Subject: Caliber Collision - Commercial Preliminary Development Plan
710 SE Blue Parkway, Lee's Summit, MO 64063

Application No: PL2021279

This letter is being sent to confirm the receipt of the City's review comments during the Analysis of the Commercial Preliminary Development Plans (PDP) for Caliber Collision at the subject address. Below are the comments received followed by the response of how they were addressed:

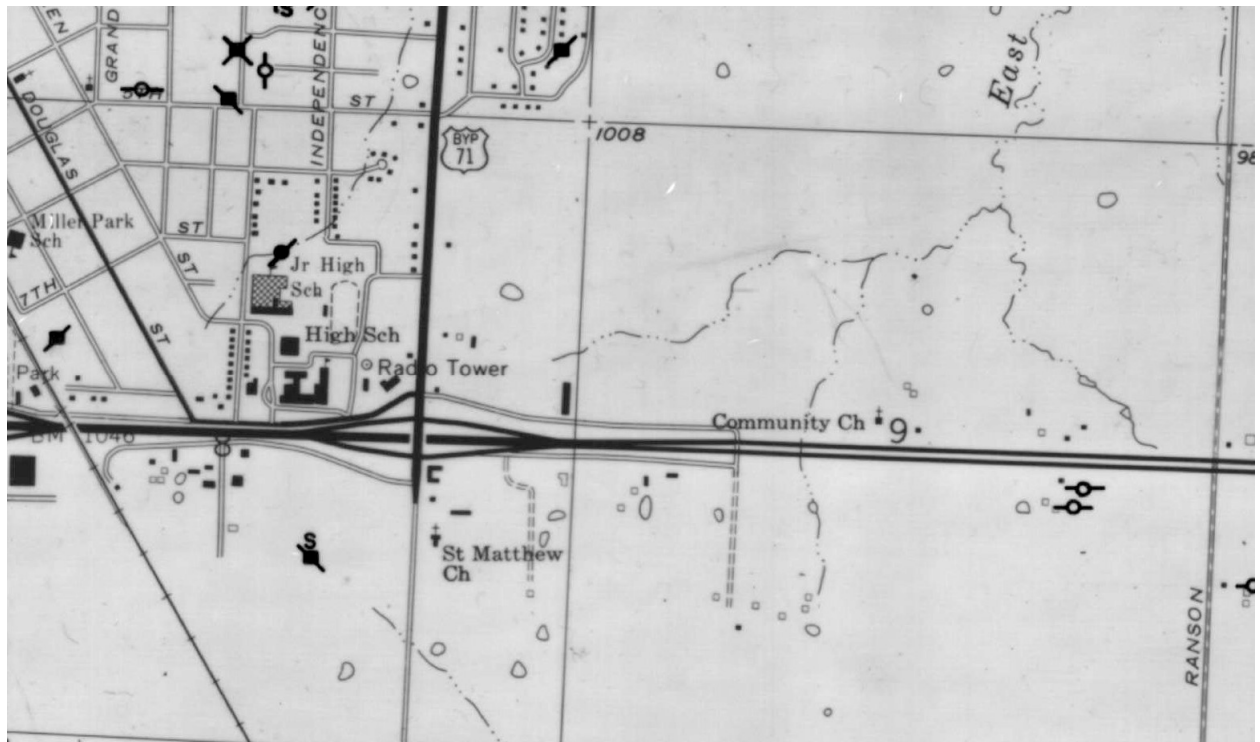
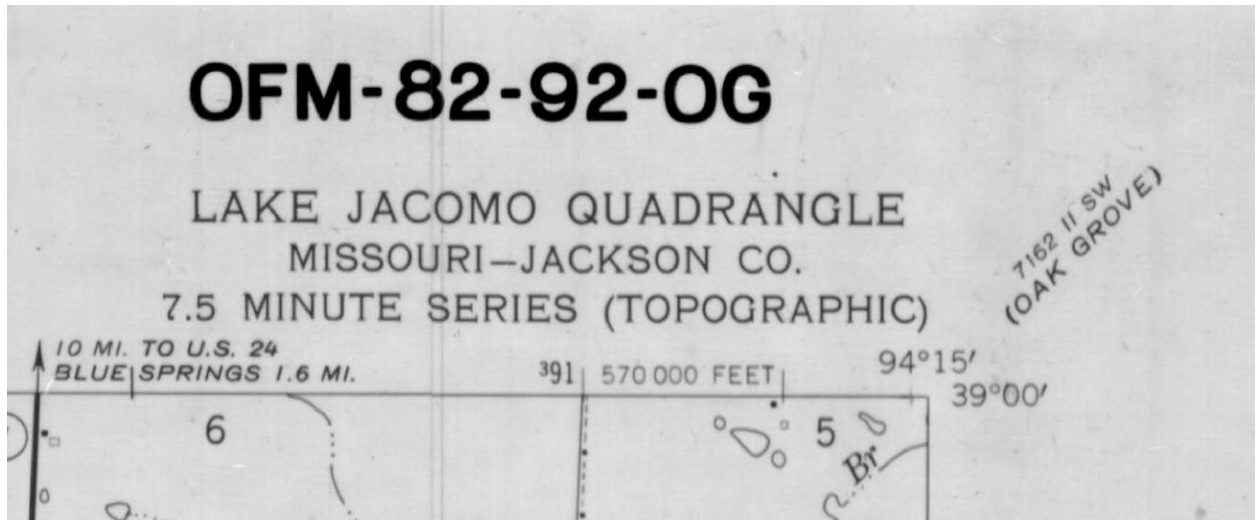
2. Oil and Gas Wells. Please state whether or not there are active, inactive, or capped wells with the area. Refer to DNR Well Database and reference the site.

RESPONSE: Per the MoDNR Well Database for Oil and Gas Wells, there were not active, inactive, or capped wells located on the property. An image from the Map is shown below.
